SERVICE INSTRUCTION

Introduction of new floats (pair) for ROTAX® Engine Type 912 and 914 (Series)

Introduction of new floats (pair) for ROTAX® engine type 912 and 914 (Series).

Fig. 1
Comparison of floats

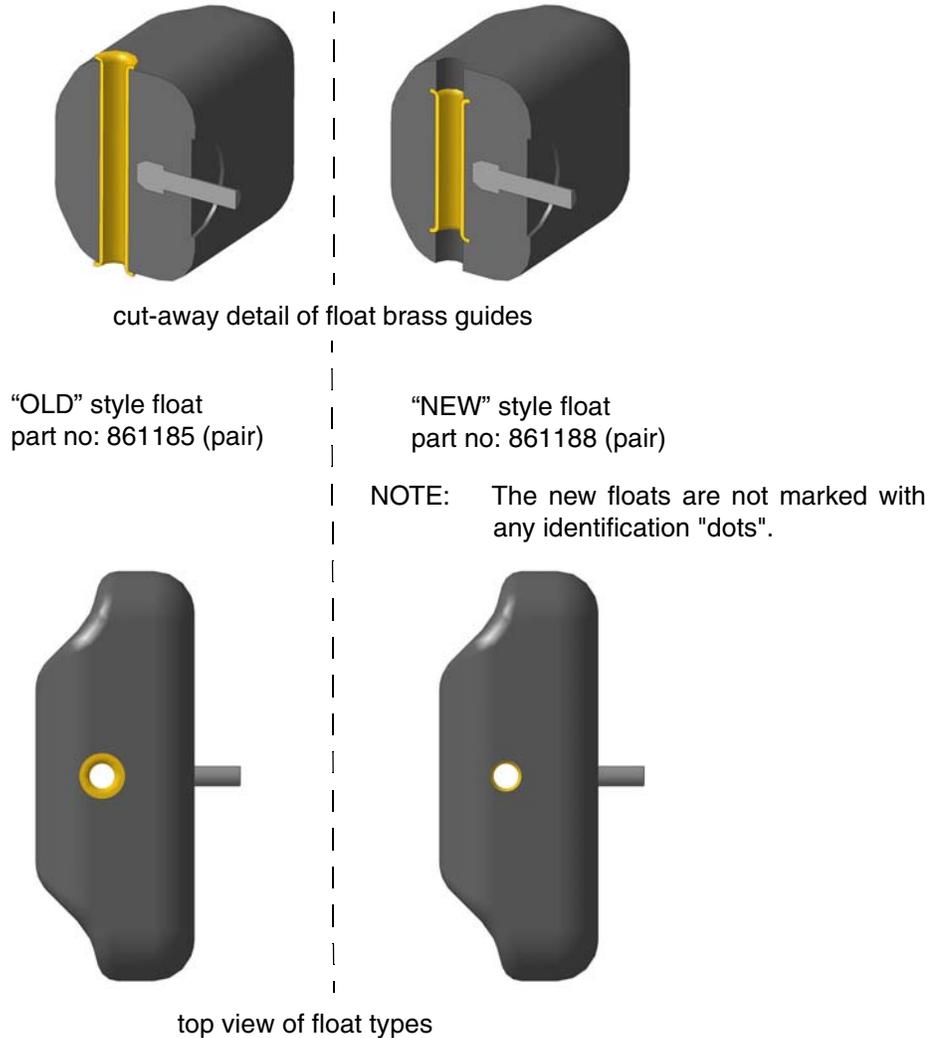
In the course of continuous development and standardization, new floats (pair) ROTAX® part number 861188 have been introduced. These new floats (pair) are manufactured with a higher compaction rate and contain a recessed brass guide. See Fig. 1.

As per Maintenance Manual Line (MML) let the floats dry for 1-2 minutes. Only weigh dry floats. Due to their higher compaction rate, the dry weight of the new floats (pair) part no. 861188 may be higher than the previous floats. But in no case the max. weight (of both floats together) is allowed to exceed 7 grams and so still applies. See relevant Maintenance Manual Line Chapter 12-20-00.
